Re: **Solena Estate (PWS #[95738](#))
2013 Well #1 (L112357, [YAMH56573](#)), Tank, and Secondary Treatment
Conditional Approval ([PR #60-2024](#))**

Solena Estate (PWS #95738) – 2013 Well #1 Conditional Approval LTR (PR #60-2024)

Approximate 50-, 100-, and 500-ft radii around the well:

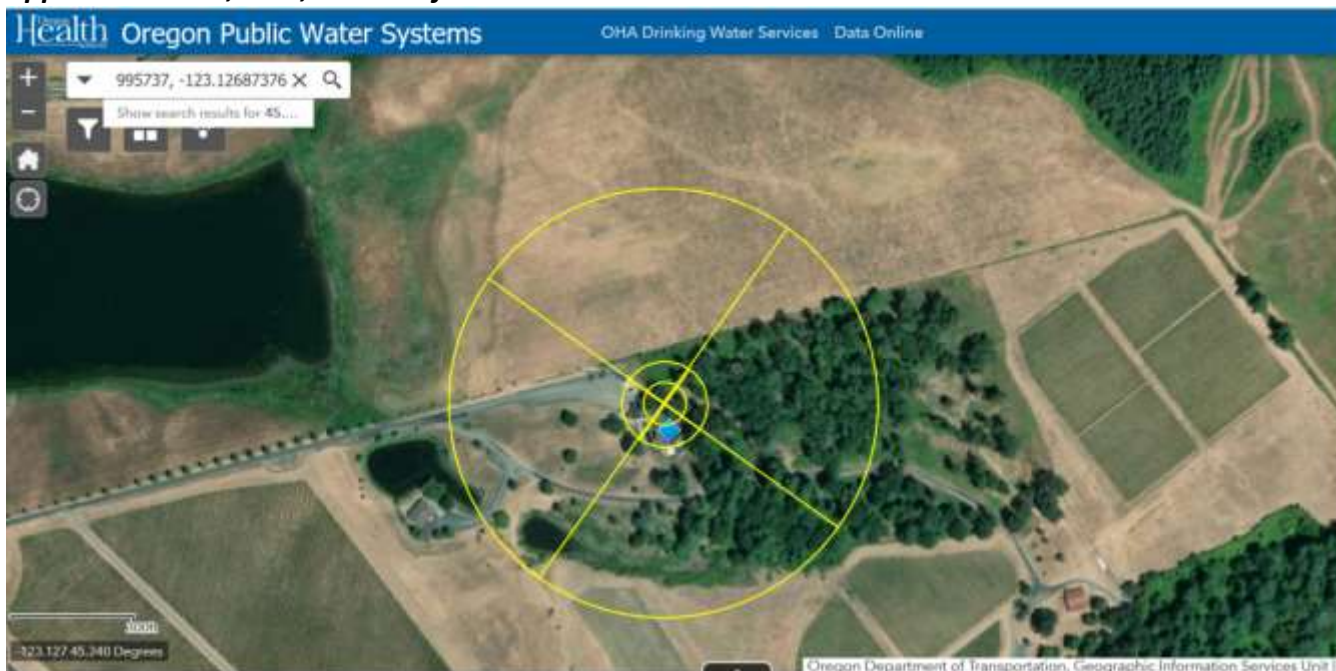
“...well construction does not contribute to the overall sensitivity of this water source to nearby land use practices” [and] “...the aquifer is not highly sensitive to nearby land use practices.” [having a] “...low susceptibility to activities associated with the roadway that occurs within the 100 ft sanitary setback.”

Comments: This well is designed to draw water from a confined sedimentary bedrock aquifer. The water-bearing zone is reported to occur between 61 and 97 ft below ground level and is overlain by 57 ft of siltstone (claystone) and silt (clay) of low permeability that act as a confining layer. Water within the aquifer is under pressure, rising 36 ft above the identified water-bearing zone to a final static water-level of 25 ft below ground. Sensitivity Analysis results suggest that the aquifer is not highly sensitive to nearby land use practices.
